Addendum No. 2 Main Pump Building HVAC Upgrades Capital Project No. 2002

This Addendum No. 2, dated January 13, 2020, to the Invitation to Bid: Main Pump Building HVAC Upgrades, Capital Project No. 2002, bid opening January 16, 2020 at 1:00 pm, supersedes all contrary and conflicting information in the above-mentioned instructions, specifications, and contract documents which are hereby supplemented or revised in certain particulars as follows:

MOTOR ROOM/LOWER SCREEN ROOM FLOOR PLAN - MECHANICAL NEW WORK SCALE: 1/4" = 1'-0"

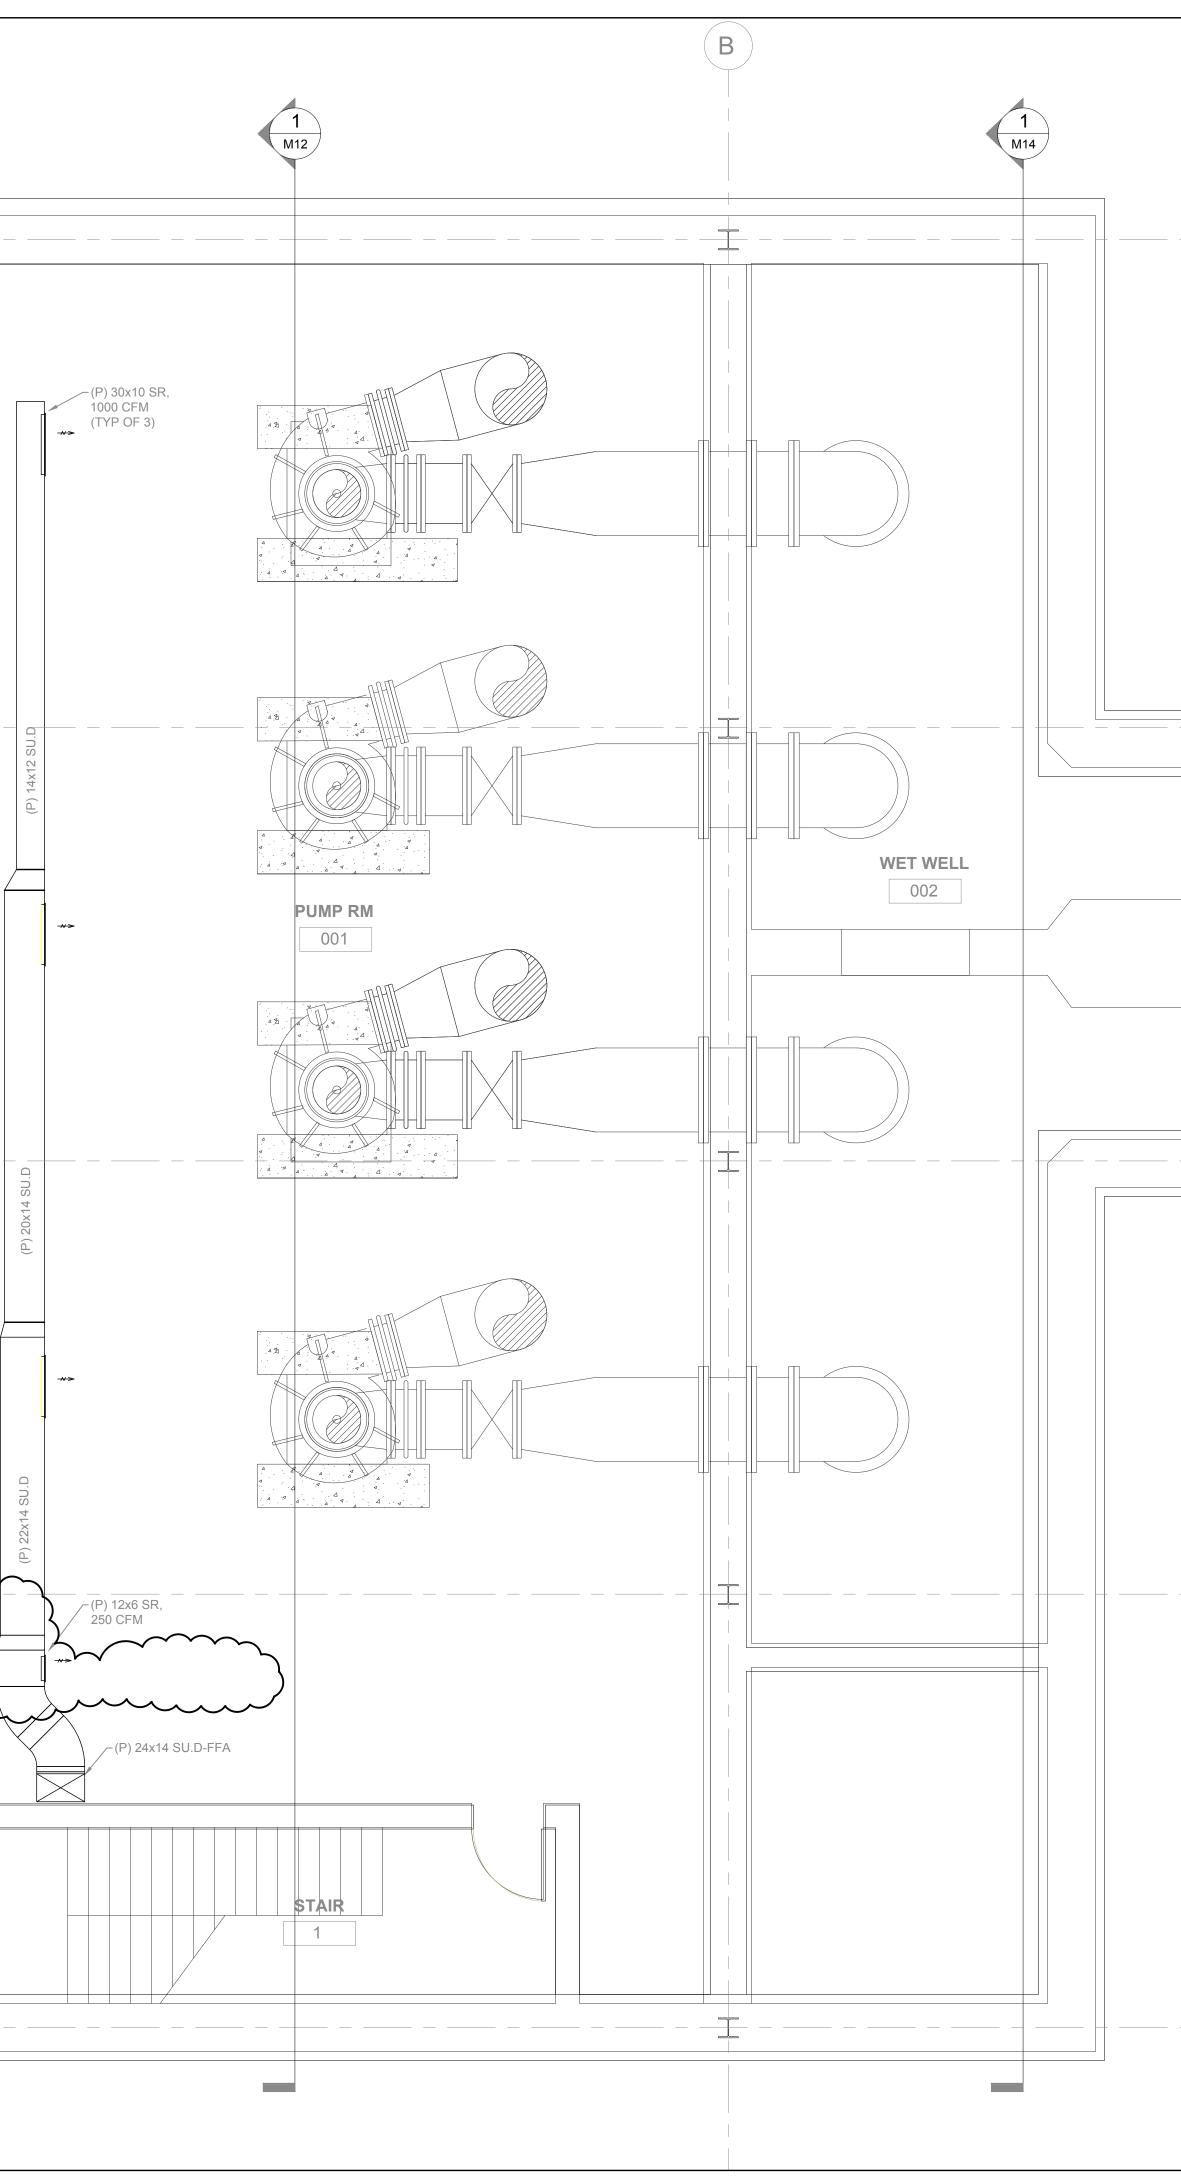
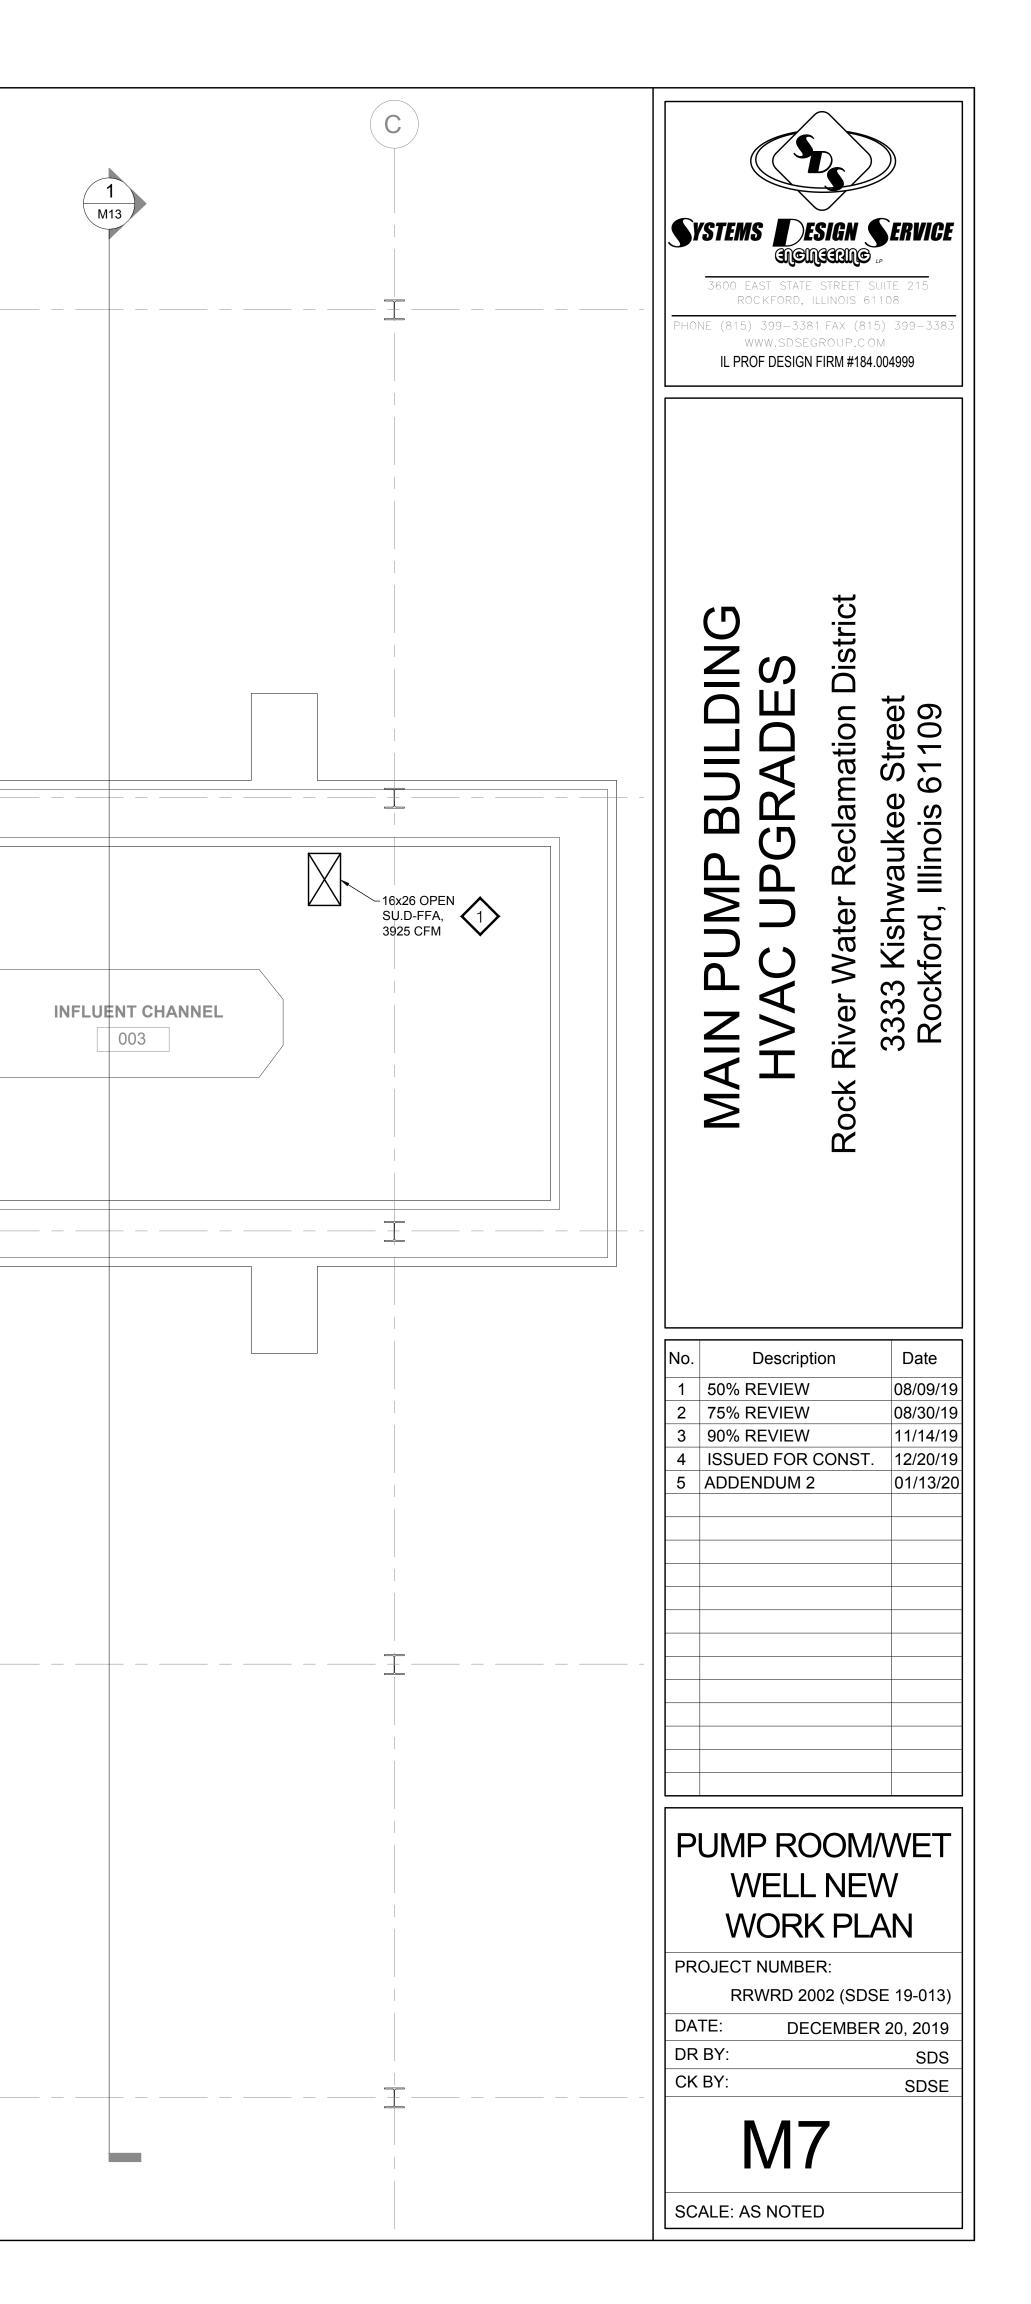
AD2-7 Sheet M7

Replace this drawing with the attached revised M7. The revisions include removal of Key Note 2 and elimination of the 16 x 60 return duct to floor above.
